# DEVELOPMENT REVIEW BOARD REPORT

CASE NUMBER/ PROJECT NAME	<b>89-DR-2005</b> <b>The Showrooms @ Hayden</b>		
LOCATION	7955 E. Redfield Road		
REQUEST	Request approval of a site plan and elevations for construction of a new showroom/warehouse facility to replace an existing vacant building.		
OWNER	Orsett Properties, LTD 602-241-3220	ENGINEER	N/A
ARCHITECT/ DESIGNER	DFD Cornoyer Hedrick 602-381-4848	APPLICANT/ COORDINATOR	Mike Edwards DFD Cornoyer Hedrick 602-381-4848

# **Stipulations for Case: The Showrooms @ Hayden 89-DR-2005**

## SITE PLAN

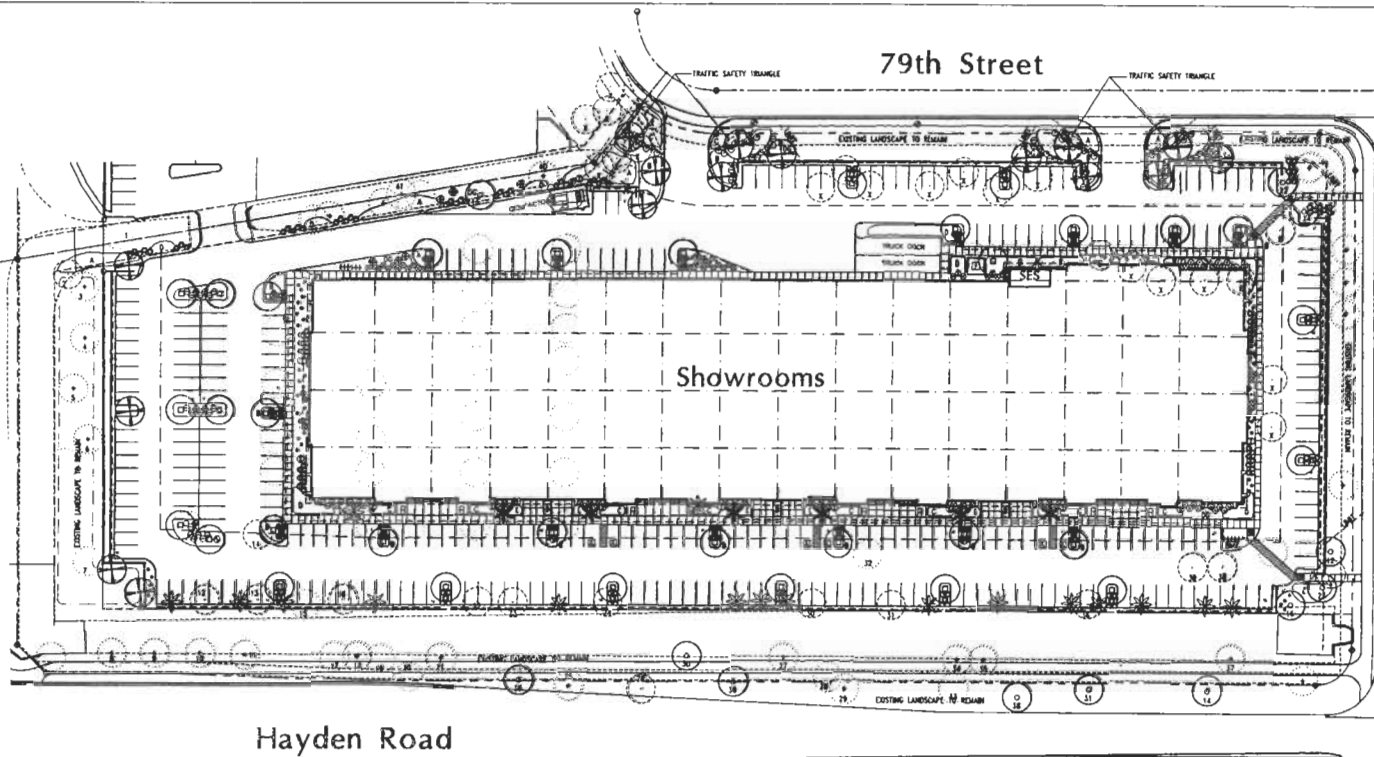
11. *The site plan shall be revised to show a pedestrian connection, from the street to the building, at both driveway locations on 79<sup>th</sup> Street, to the satisfaction of final plans staff.*

12. *The proposed truck docks, located along the west side of the building, shall be sub-grade, or sufficiently screened from off-site view with a block wall or similar barrier.*

13. *A pedestrian walkway not less than thirty-six inches in width shall be provided adjacent to the parking spaces located along the west side of the building, south of the truck docks, to the satisfaction of final plans staff. The thirty-six inches shall be measured from the building to the edge of the parking space overhang.*

The proposed refuse enclosure shown on the preliminary site plan, does not meet the minimum City of Scottsdale requirements. The developer shall be responsible to provide one enclosure per 20,000 square feet of proposed space. However, any deviation from this rule, as it may be applicable to this site (serving mostly as a furniture showroom), shall require the approval of the Sanitation Department of the City of Scottsdale prior to final plans submittal.
